Wildlife, Hydrology, and Engineering Technical (WHET) Committee Recommendations

Decision Point #1: Large Crossing Structure Types, Sizes, and Locations from MP 62 to MP 70

Bonnie Creek CEA

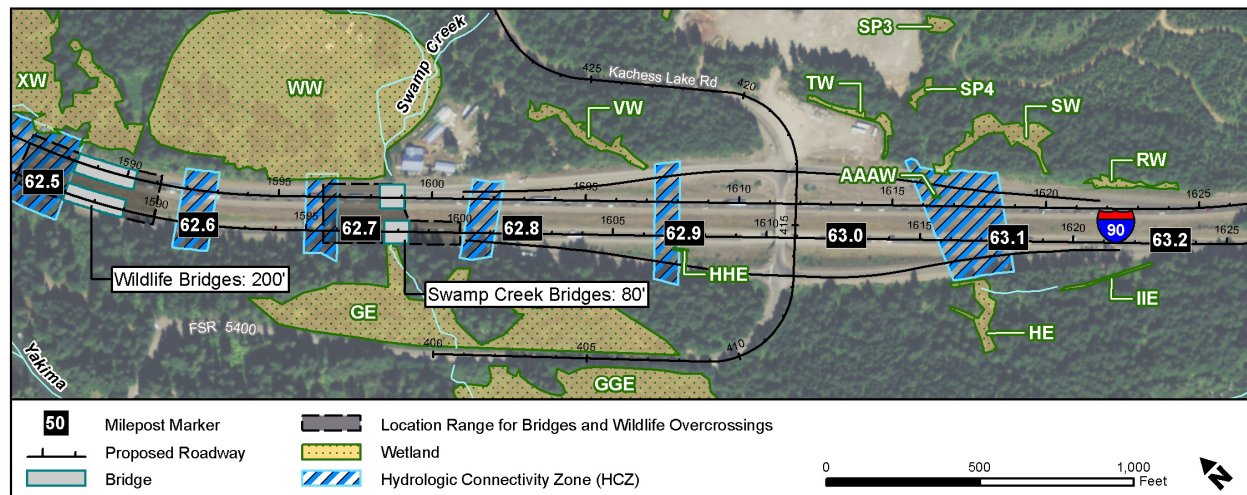
Bonnie Creek CEA is located between MP 61.9 and 62.5, and includes opportunities to reconnect high value habitats on either side of the highway including mature forest and high-quality forest wetlands. The Selected Alternative design included eastbound (EB) and westbound (WB) 600 foot bridges at MP 62.3, spanning Bonnie Creek and an unnamed creek, with at least 16 feet of vertical clearance.

Our recommendation for the Bonnie Creek CEA matches the Selected Alternative: construct EB and WB 600 foot bridges at MP 62.3, spanning Bonnie Creek and an unnamed creek with 13 to 16 feet of vertical clearance.

We did not identify any constraints that would require changes to the structure type, size, or location at Bonnie Creek CEA. We will continue to work to maximize vertical clearances under the bridge as designs progress.

Swamp Creek CEA

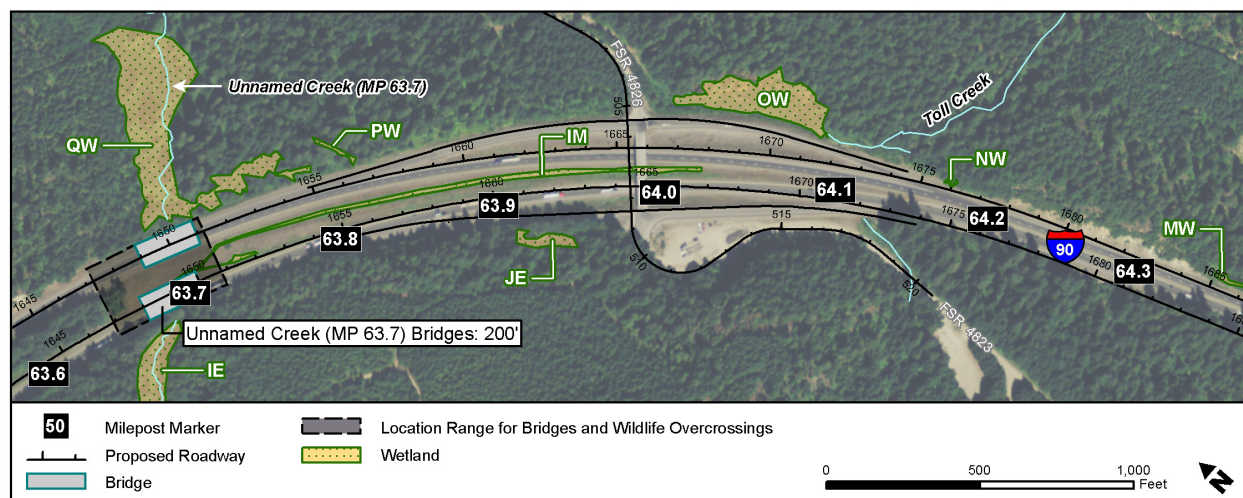
Swamp Creek CEA is located between MP 62.5 and MP 63.4, and has the potential to provide important linkages between unique wetland/marsh habitats. The Selected Alternative included EB and WB 120 foot bridges at MP 62.5, Swamp Creek (MP 62.7), and MP 63.2, with at least 16 feet of vertical clearance.

The Stampede Pass Interchange at MP 63 constrains the road profile, which affects vertical clearances achievable on either side of the interchange. Raising the interchange is not a favorable option because it would require increasing the profile and footprint of the adjoining roadways (Kachess Lake Road and FS Road 54) and increases impacts to nearby forest and wetlands. We also recognized that private property ownership north of I-90 presented a high risk of human use and incompatible land use with our wildlife connectivity investments in this location.

The Stampede Pass Interchange and nearby private property precluded us from locating a large structure between MP 62.6 and 63.4. Under these constraints, it was not possible to meet functional equivalence within just the Swamp Creek CEA. There were fewer constraints with the highway profile within the Toll Creek CEA (MP 63.5 to 64.2) and it is within the same wildlife linkage zone as Swamp Creek.

As part of our review we also discussed that fitting a 120 foot bridge structure in Swamp Creek would result in excavation through a natural glacial outwash feature and be inconsistent with USFS Riparian Reserves and Aquatic Conservation Strategy objectives. The 80-foot bridges accommodate the Swamp Creek 100-year flood and reconnect wetland habitats, and we are can still meet our connectivity objectives for high-mobility wildlife with the neighboring 200 foot structures at MP 62.5 and MP 63.7.

- For the unnamed creek at MP 62.5, increase the bridge lengths to 200 feet with 13 to 16 feet of vertical clearance. We will continue to work to maximize vertical clearances under the bridge as designs progress.
- For Swamp Creek, decrease the bridge length to 80 feet with 10 to 12 feet of vertical clearance due to its proximity to the Stampede Pass Interchange and incompatible land use north of the highway.
- Remove the 120 foot bridge at unnamed creek at MP 63.2 due to its proximity to the Stampede Pass Interchange and expected low vertical clearance. We will continue to explore opportunities with WSDOT to restore Swamp Creek to its historic channel

south of I-90 by shifting EB and WB bridge locations to best fit historic conditions.

The Selected Alternative design within the Swamp and Toll Creek CEAs included 120-foot bridges at MP 62.5, 62.7, 63.2, and 63.7 equaling 480 feet of bridge length. Our recommendation for these structures consists of 200 foot bridges at MP 62.5, 80 foot bridges at Swamp Creek (MP 62.7), and 200 foot bridges at MP 63.7 that still equals 480 feet of bridge length. Both options provide four large structure equivalents with a total of 480 feet of bridge.

Toll Creek CEA

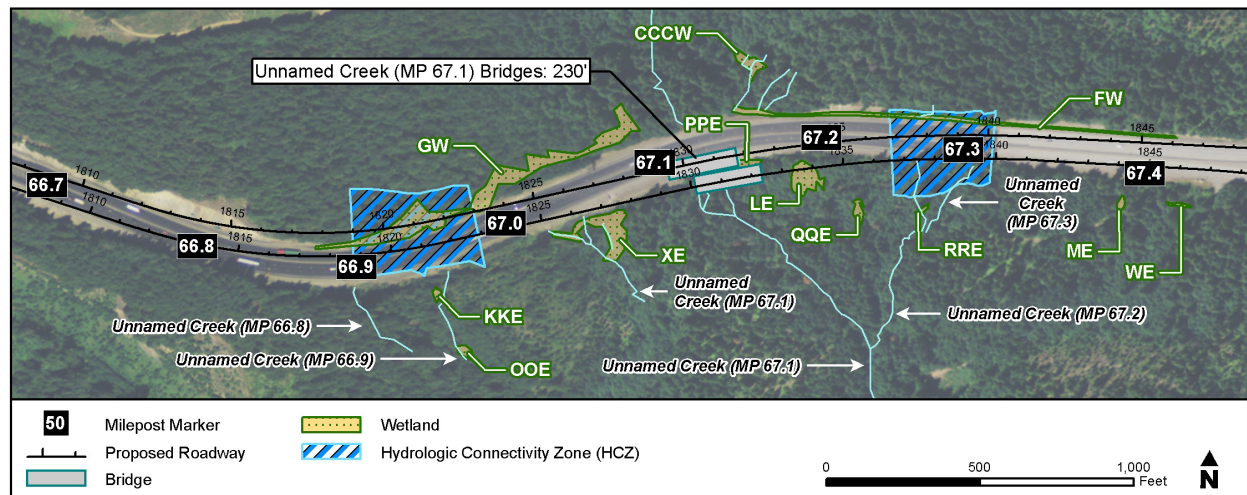
The Toll Creek CEA is located between MP 63.5 and 64.2, and has the potential to reconnect species associated with mature forest habitats. The Selected Alternative included EB and WB 120 foot bridges at MP 63.7, spanning the unnamed creek at this location, with at least 16 feet of vertical clearance.

Our recommendation for Toll Creek is to construct 200 foot bridges at MP 63.7, with 14 to 16 feet of vertical clearance. The increase in bridge length accounts for the reduced bridge length at Swamp Creek and removal of the proposed bridges at MP 63.2. We will continue to work to maximize vertical clearances under bridges as designs progress.

Refer to Swamp Creek CEA for a discussion of the rationale for our recommendation. The proposed 200 foot bridge in the Toll Creek CEA (MP 63.7) is approximately 0.5 miles east of the Swamp Creek CEA.

Hudson Creek CEA

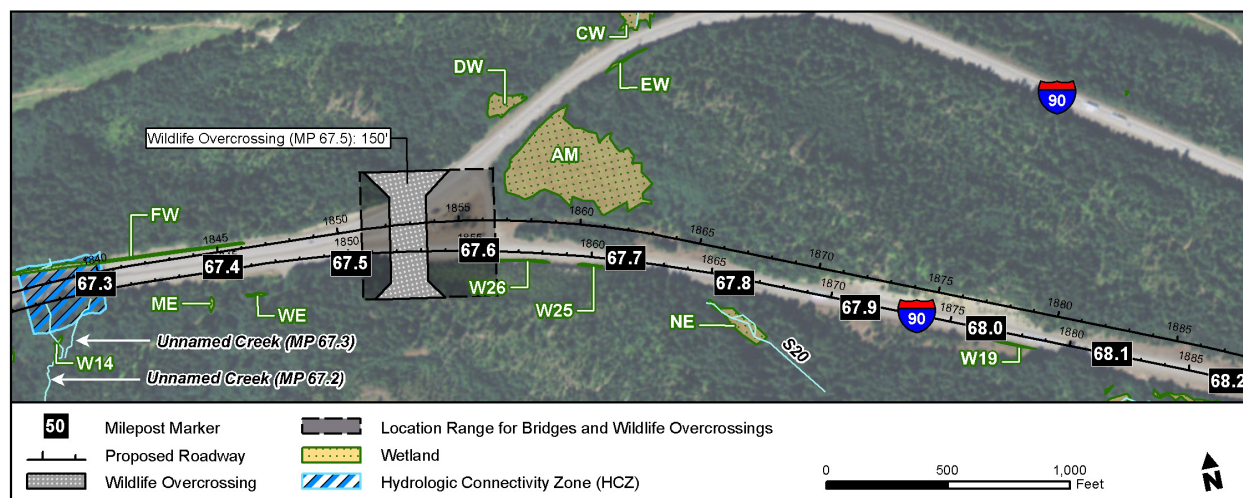
The Hudson Creek CEA is located between MP 66.8 and 67.3, and provides the best opportunity in the project area to provide connectivity for species associated with talus habitat. The Selected Alternative included EB and WB 230 foot bridges at MP 67.1, spanning the unnamed creek at this location, with at least 16 feet of vertical clearance.

Our recommendation for Hudson Creek CEA matches the Selected Alternative: construct EB and WB 230 foot bridges at MP 67.1, spanning the unnamed creek at this location, with at least 16 feet of vertical clearance.

We did not identify any constraints that would require changes to the structure type, size, or location at Hudson Creek CEA. Current designs suggest that the vertical clearance under this structure will exceed that of the structure in the selected alternative. We expect increased vertical clearance to improve the performance of this structure in terms of meeting connectivity objectives. Increased clearance may enhance development of natural vegetation under the bridges, improving performance for low-mobility species, and increased openness may accommodate preferences of more species of wildlife and result in lower repulsion rates for high-mobility species.

Easton Hill CEA

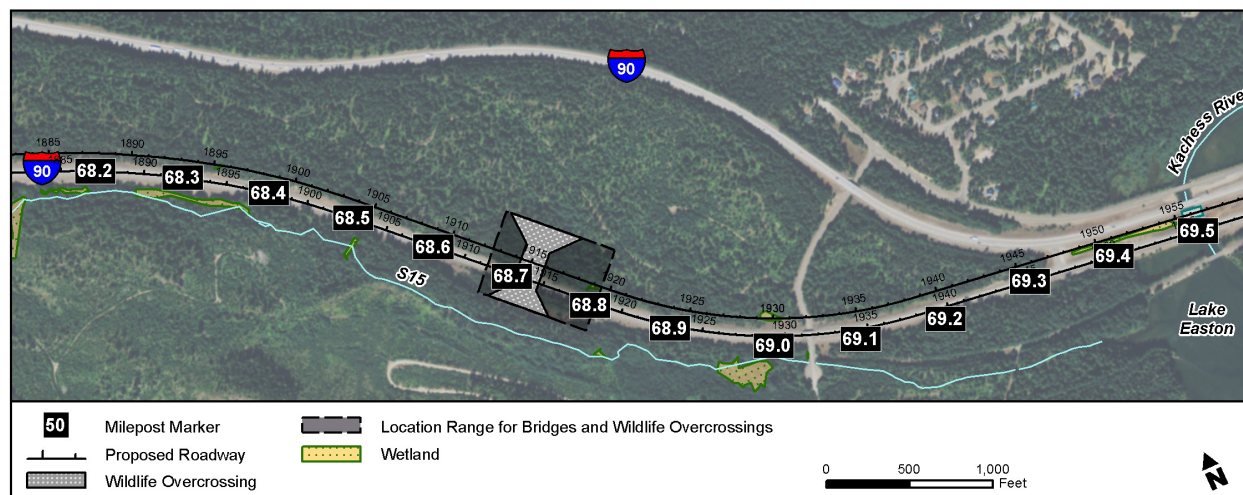
The Easton Hill CEA is located between MP 67.3 and 68.0, and provides critical wildlife linkage between high-quality habitats associated with the roadless areas south of I-90 to roadless areas located between Kachess Lake and Lake Cle Elum, which in turn link to the Alpine Lakes Wilderness. The Selected Alternative design was based on the split highway alignments at Easton Hill, and included EB and WB 120 foot bridges at MP 67.6 with at least 16 feet of vertical clearance.

The split alignments at Easton Hill, coupled with the area topography, result in challenges for meeting wildlife connectivity objectives within the Easton Hill and Kachess River CEAs. A split roadway also poses a challenge for the design and installation of wildlife exclusion fence. Either a fence corral would be needed across the median between the EB and WB structures, or both sides of each alignment would need to be fenced, doubling the total fence length. Bundling the alignments helps solve these issues.

The highway profile at MP 67.6 will not accommodate the bridges included in the Selected Alternative; however, the topography on either side of the highway lends itself to an overcrossing. The wide-ranging species that use this area also tend to use overcrossings more readily than bridges. Our expectation is that the proposed overcrossing will perform better than the bridges in the Selected Alternative in terms of meeting wildlife connectivity objectives. This expectation is based not only on the species present in this CEA, but also because the bundled alignment should provide a more efficient and effective crossing opportunity for wildlife. Solutions for meeting hydrologic connectivity objectives in this CEA still need to be developed.

Our recommendation is to bundle the EB and WB alignments at Easton Hill, and construct a single 150 foot wildlife overcrossing near MP 67.6, spanning EB and WB lanes.
